**Blooming Grove Equip.
(SP)**

OAKWOOD_TERRACE_OFFICE_BUILDING_(01-61)

**TOWN OF NEW WINDSOR
PLANNING BOARD
REVIEW COMMENTS**

PROJECT NAME: OAKWOOD TERRACE OFFICE BLDG. SITE PLAN
PROJECT LOCATION: 17 OAKWOOD TERRACE
SECTION 44 – BLOCK 1 – LOT 41.2
PROJECT NUMBER: 01-61
DATE: 13 MARCH 2002
DESCRIPTION: THE APPLICATION PROPOSES A 7500 S.F. OFFICE BUILDING ON A THE
EXISTING LOT. THE PLAN WAS PREVIOUSLY REVIEWED AT THE
14 NOVEMBER 2001 AND 27 FEBRUARY 2002 PLANNING BOARD
MEETINGS.

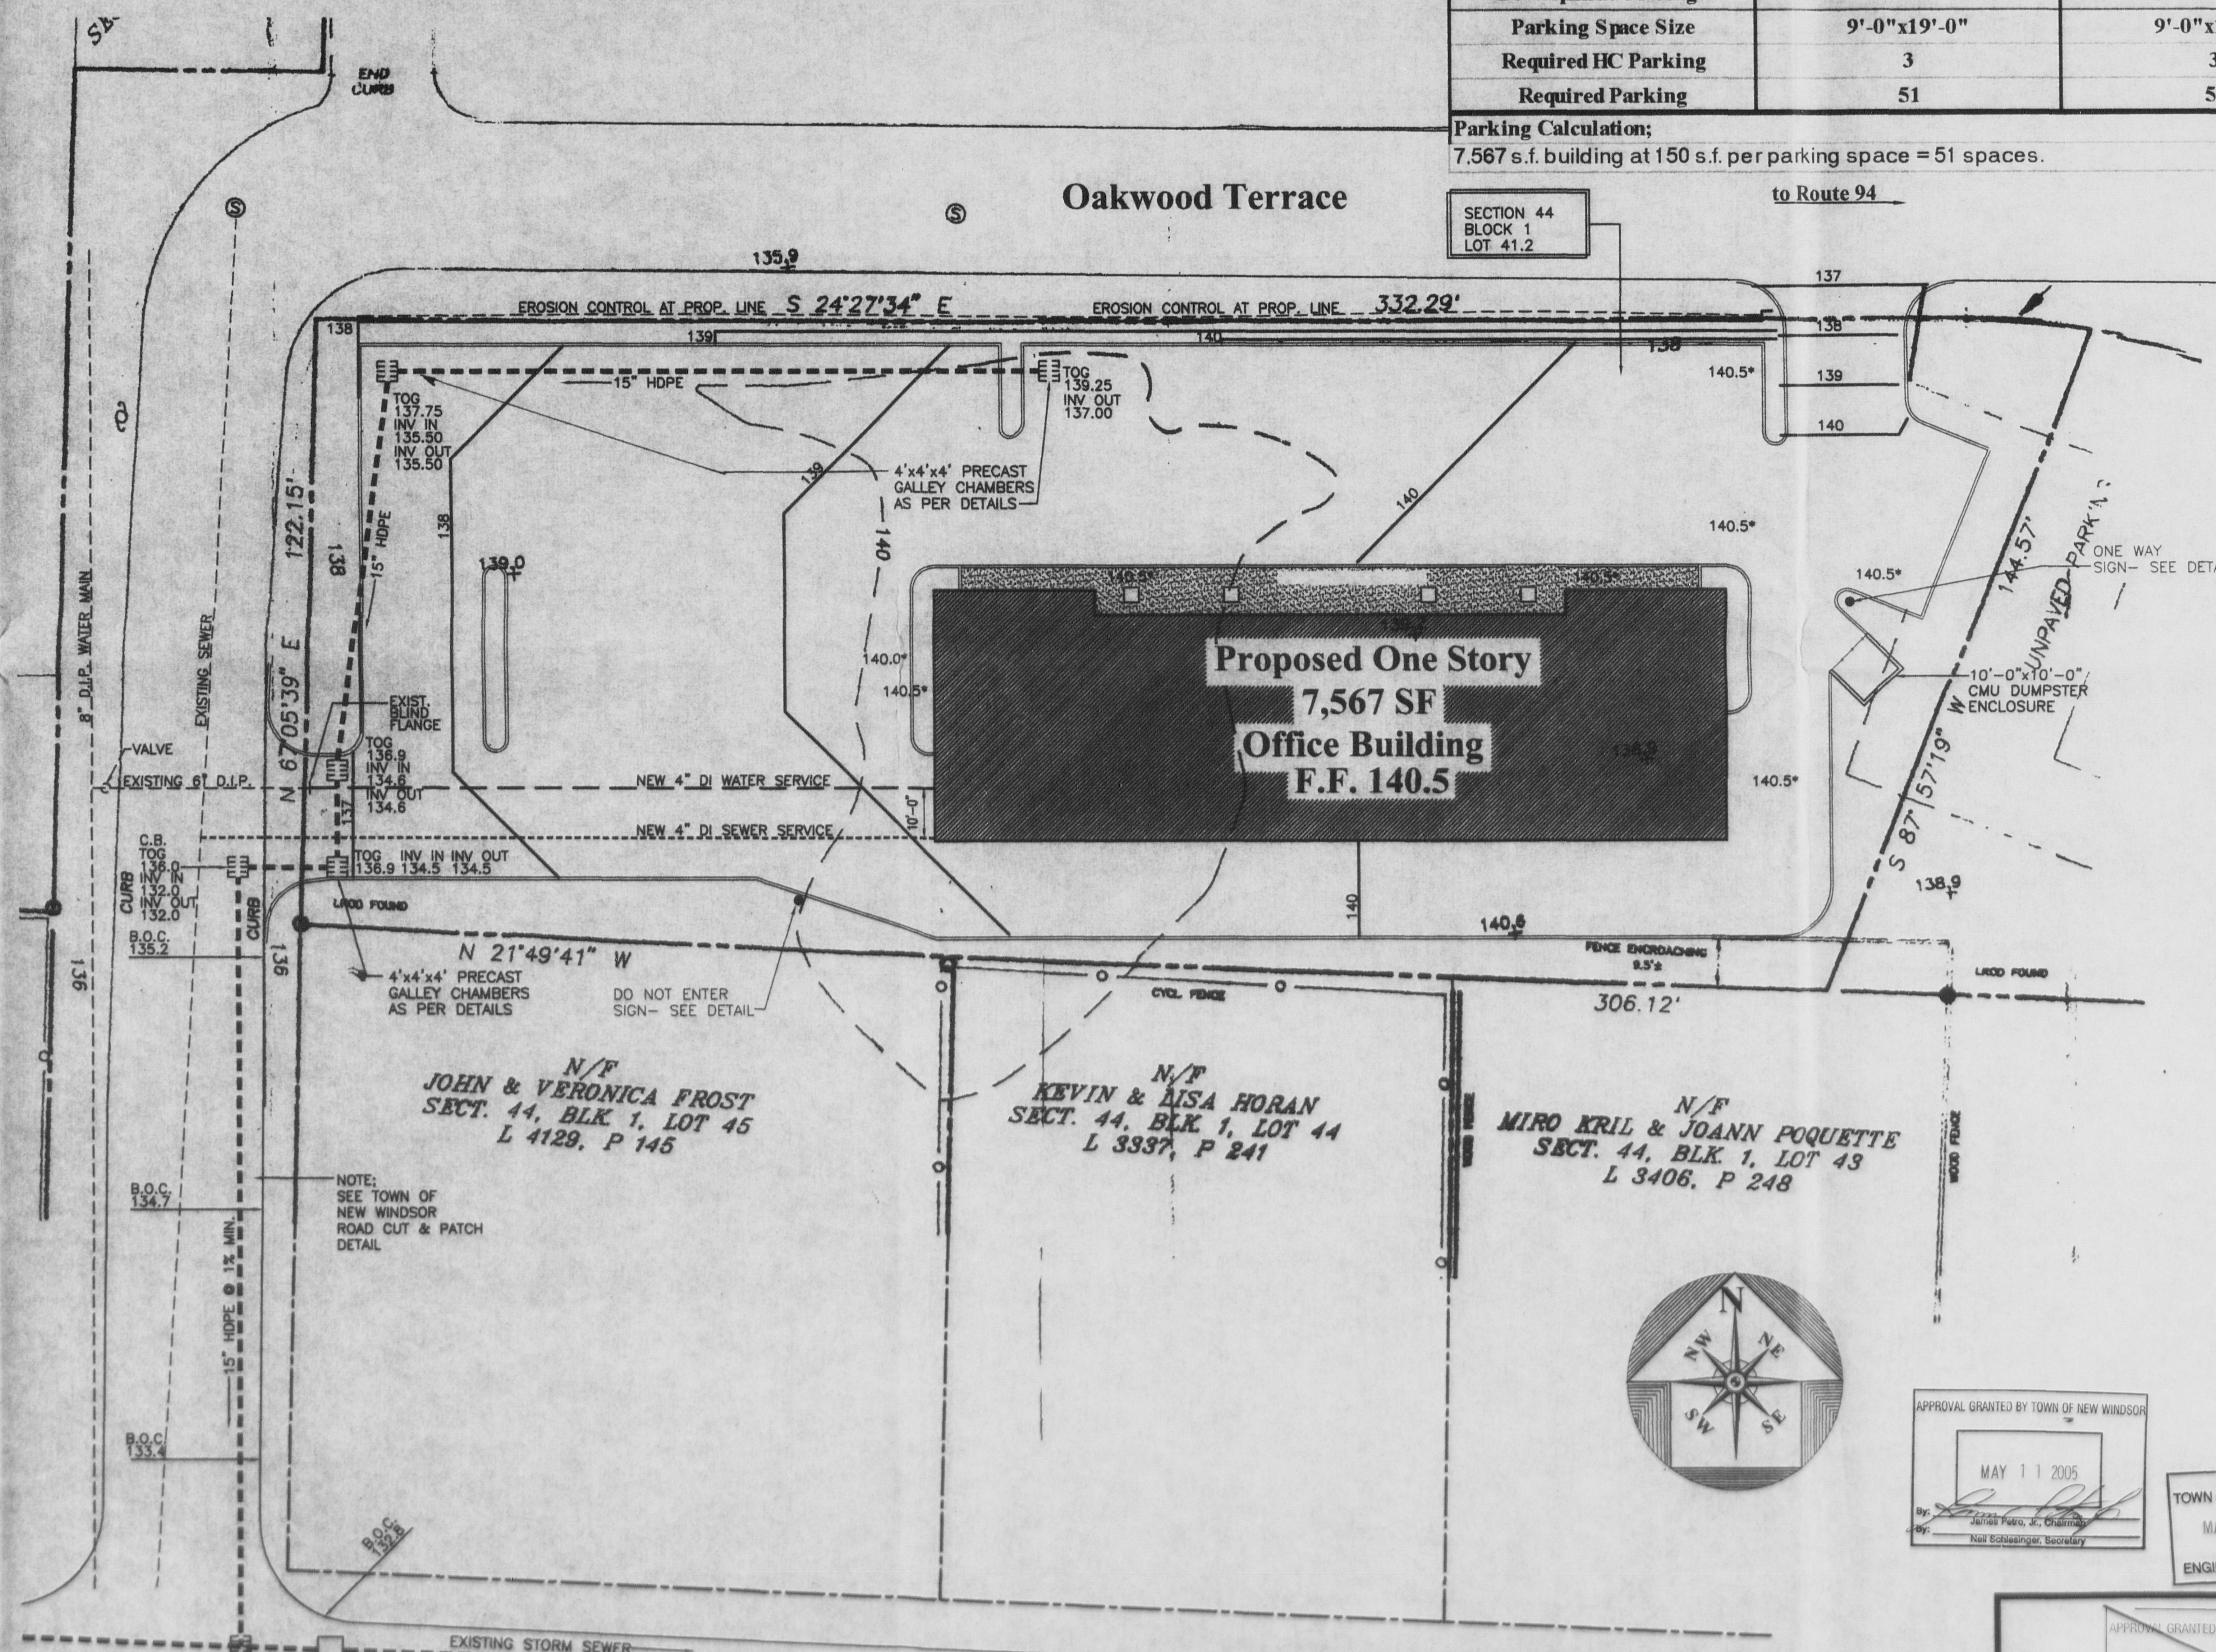
MR. EDSALL: Best I can tell. So what I'm suggesting is we approve it subject to them correcting the bulk table, demonstrating that they are 85 percent or less and they pay the reapproval fee.

2. I have review the revised plan set and have the following comments:
 - a. This site has one side yard and the rear yard (south side). Revise bulk table.

1 Pavement & Curb Detail @ Parking
SP3 Scale: 1"=1'-0"

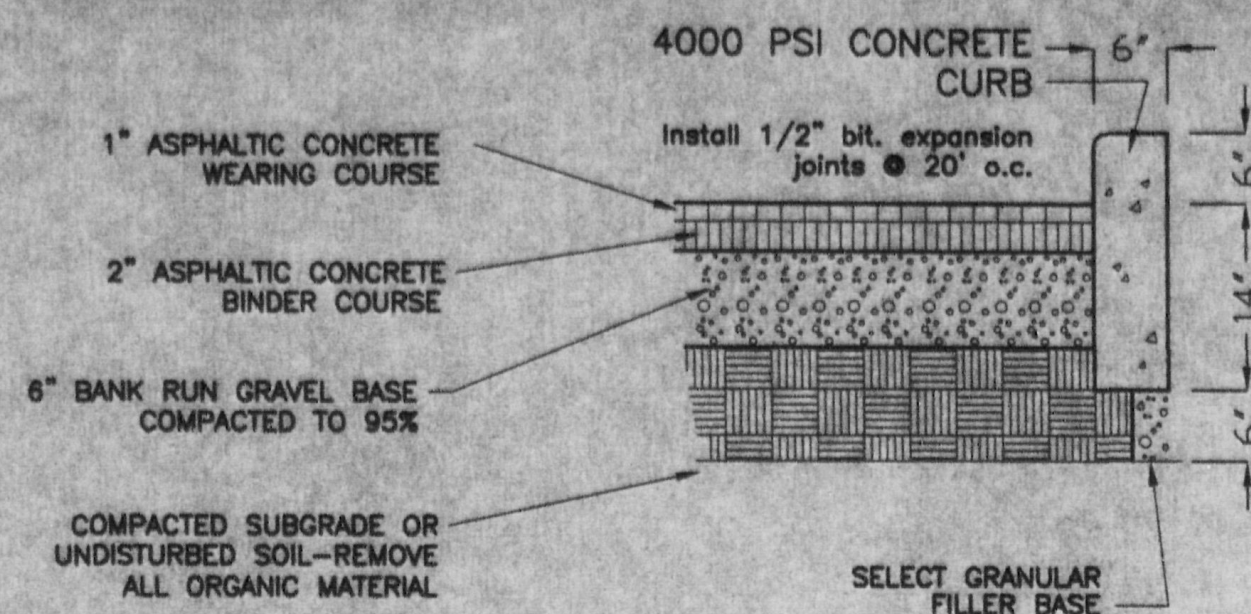
- d. Areas adjacent to the building, within the curbed area, but not sidewalk, should be noted as landscaped.
 - e. Curbs should be continuous on site. Detail 3/SP3 would appear not to apply to this site.

6 Subsurface Infiltration System
SP3 NTS

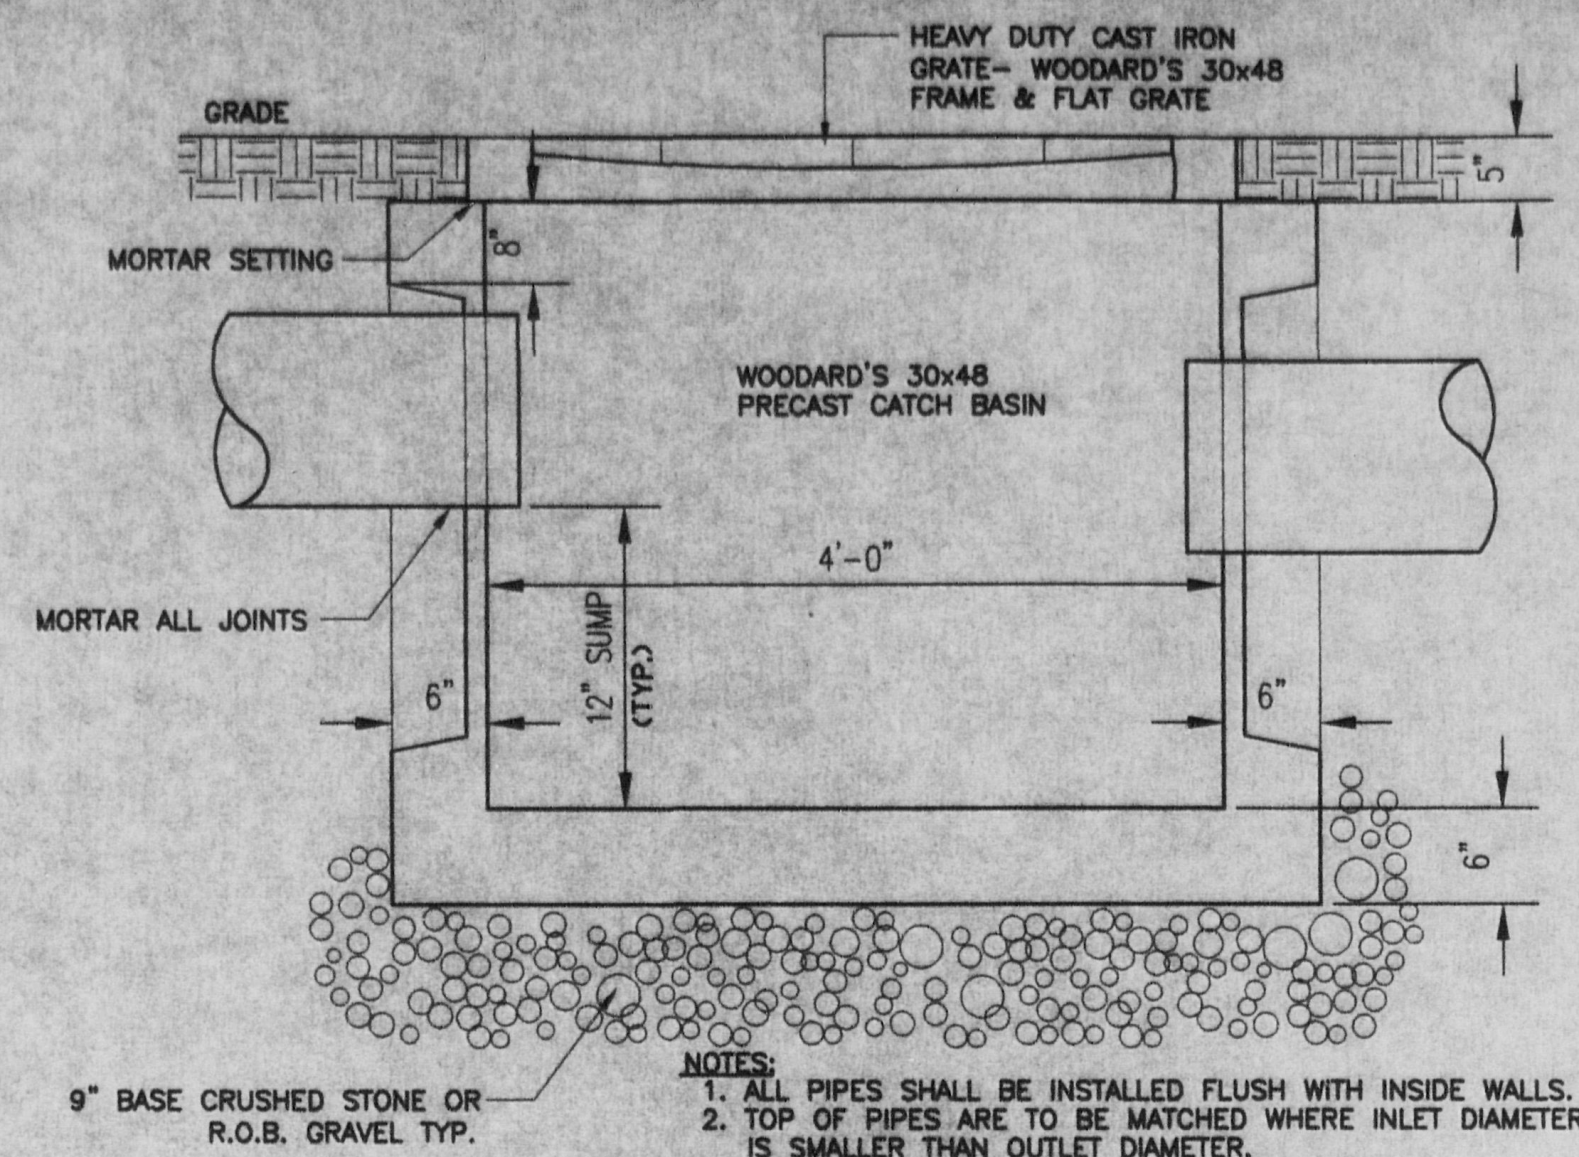
- b. The plan proposes on site drainage seepage pits with an overflow option via piping to St. Anne Drive. A drainage study has been submitted and is in review. We have also discussed this on a preliminary basis with the Highway Superintendent. We will have a joint recommendation for the next meeting.

5 Typical Pavement & Trench Detail @ Roadway
SP3 Scale: 1"=1'-0"

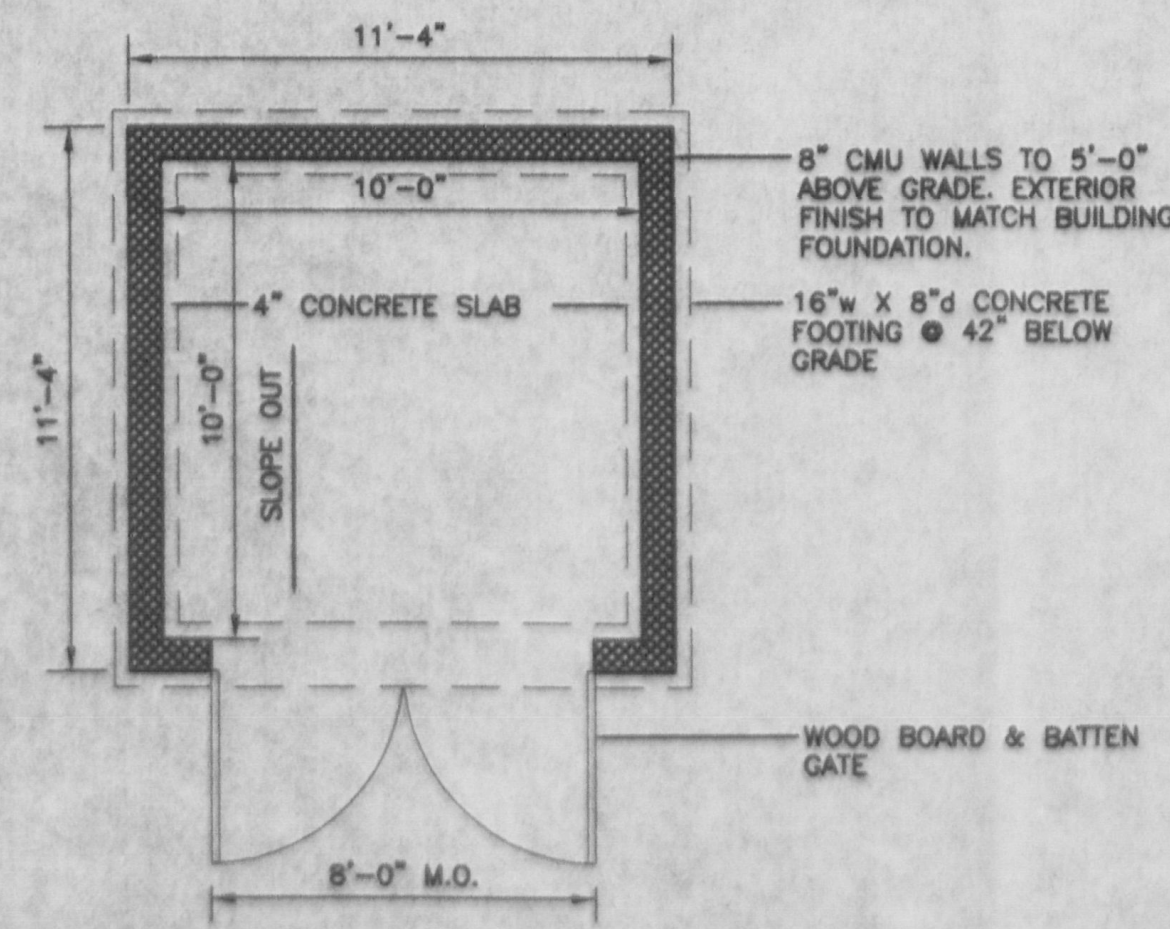
- g. The typical trench detail can not apply to trenches within Town roadway limits. Here, full depth NYSDOT Item #4 backfill (compacted) is required. Provide additional detail.

10 Sign Details
SP3 NTS

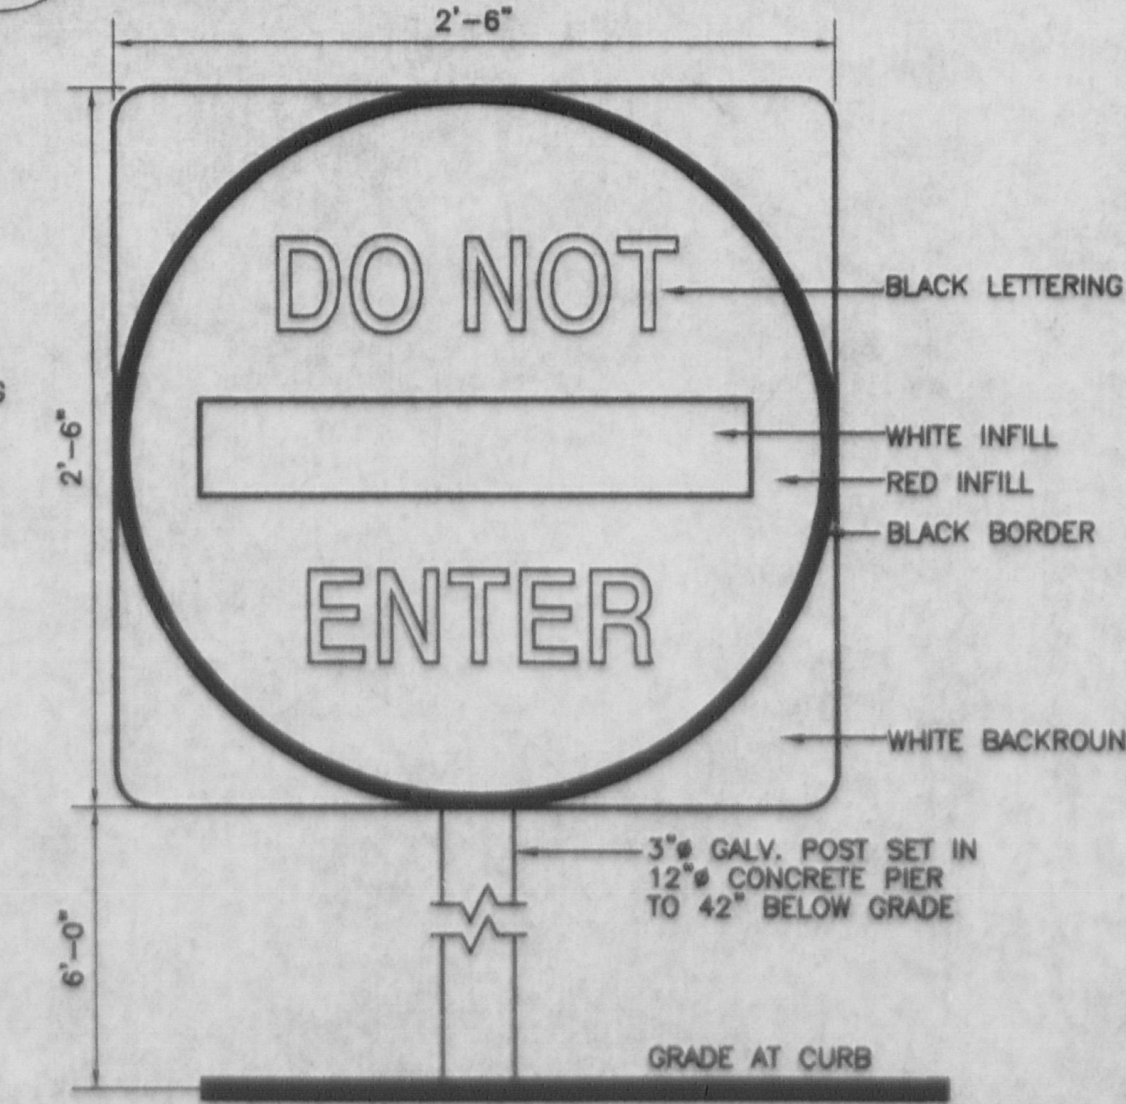
- h. The typical parking space includes a wheelstop. I would recommend against this.
 - i. Add a sign detail to the handicapped parking space detail.
 - j. Sign detail 11/SP3 is not acceptable. Utilize standard configuration NYSDOT R3-15 sign (modify dimensions if applicable). Also, relocate sign so not obstructed by landscaping.
